**NORTHEAST UTILITIES**

Millstone Nuclear Power Station, Unit No. 3  
Power Systems Branch Electrical (PSBE)  
SER Confirmatory Items 44, 45, 46 and 50

Attached are three (3) copies of revisions to Sections 8.2 and 8.3 of the Millstone Unit No. 3, FSAR. These revisions close SER Confirmatory Items 44, 45, 46, and 50 (Reference 1). All information contained in the FSAR revisions has been discussed with your Mr. John Knox, Power Systems Branch Electrical, and was provided in our responses to NRC questions 430.4, 430.5, 430.7, and 430.9, corresponding to SER Confirmatory Items 44, 45, 46 and 50, respectively. The attached revisions respond to Mr. Knox's request for the information to be incorporated in the FSAR text. Revisions are provided as they will appear in Amendment 13 of the FSAR.

FIGURE 6430.4-1 8.2-1  
MILLSTONE-MANCHESTER 345KV LINE  
MILLSTONE NUCLEAR POWER STATION  
UNIT 3  
FINAL SAFETY ANALYSIS REPORT

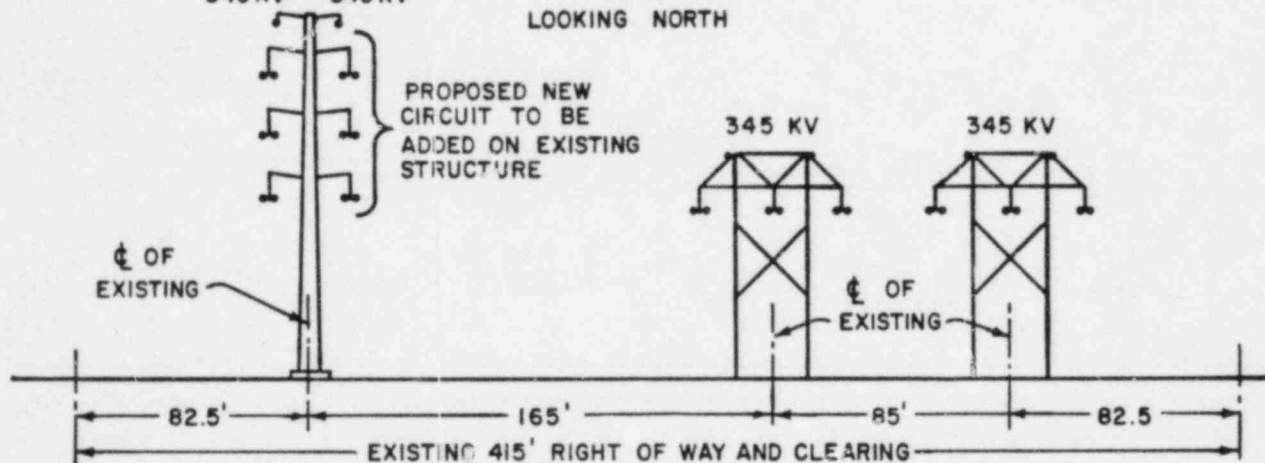
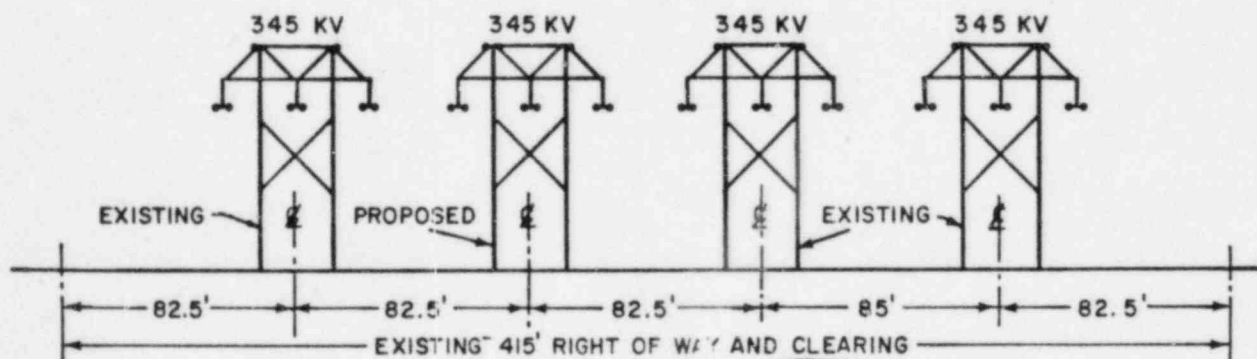
The four lines emanating from the Millstone Switching Station will be in compliance with the staff position that no other transmission lines cross over these four lines and that the four lines be physically separate and independent so that no single event such as a tower falling or line breaking will be able to simultaneously affect all circuits in such a way that none of the four circuits can be returned to service in time to prevent fuel design limits or design conditions of the reactor coolant pressure boundary from being exceeded. Figure 8.2-1, taken from the Connecticut Siting Council Docket No. 25, Application for the Millstone to Manchester 345 kV line, shows the right-of-way cross sections between Millstone and Hunts Brook Junction. The double circuit steel pole structures between Millstone and I-95 average 120 feet above ground while the wood pole H-frame structures between Daniels Avenue and Hunts Brook Junction average 85 feet above ground.

In the event of a structure failure between Millstone and Hunts Brook Junction, the worst probable longer-than-momentary outage would be a loss of two circuits; i.e., the two circuits on a common steel pole or an H-frame structure falling into an adjacent line.

FIGURE Q430.4-2 8.2-2  
HUNTS BROOK JUNCTION  
MILLSTONE NUCLEAR POWER STATION  
UNIT 3  
FINAL SAFETY ANALYSIS REPORT

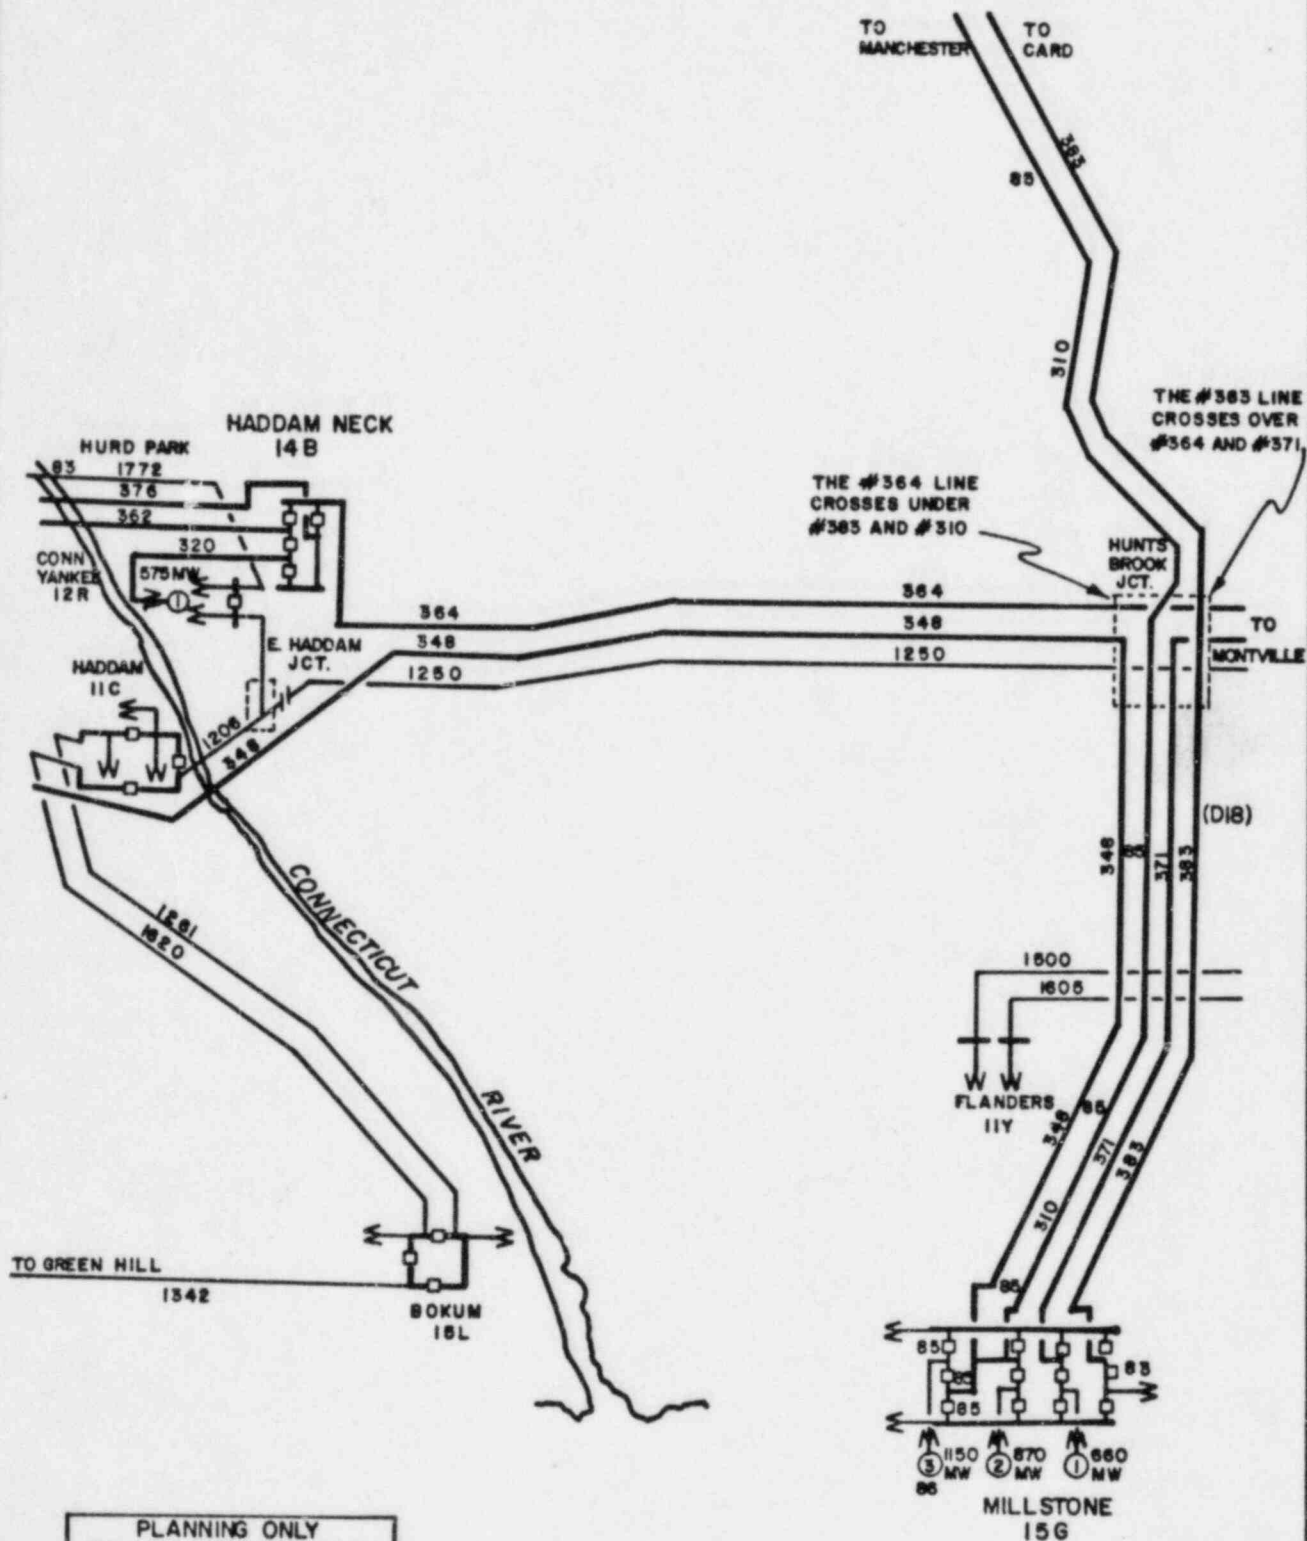
At Hunts Brook Junction, the four lines split (see Figure 8.2-2). The 348 line turns west to Southington Substation, the 383 and new 310 lines continue north to Card Street and Manchester Substation respectively, and the 371 line turns east to Montville Substation. One aerial crossover of a line from Millstone exists at this junction (383 crosses 371). But, at worst, only two of the four circuits from the Millstone Switching Station would be removed from service should a structure collapse.
